# TECHNICAL SERVICE BULLETIN

76-F-1

FRONT SUSPENSION TURRET

TR7

Fig. 1

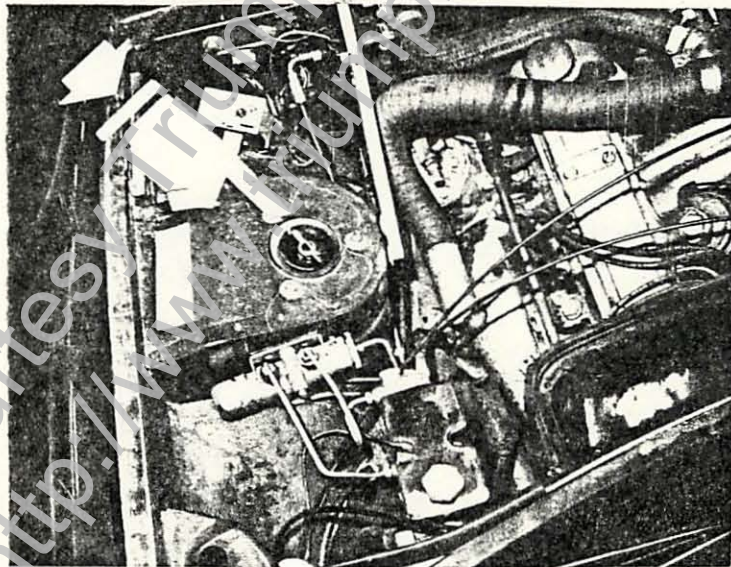
Water ingress at the upper mounting position of the front suspension turret can cause partial seizure of the upper bearing surface which results in heavy steering being experienced by the driver.

A simple solution to this problem is to pack the area shown in Fig. 1 with heavy grease. This operation should be carried out during pre-delivery.
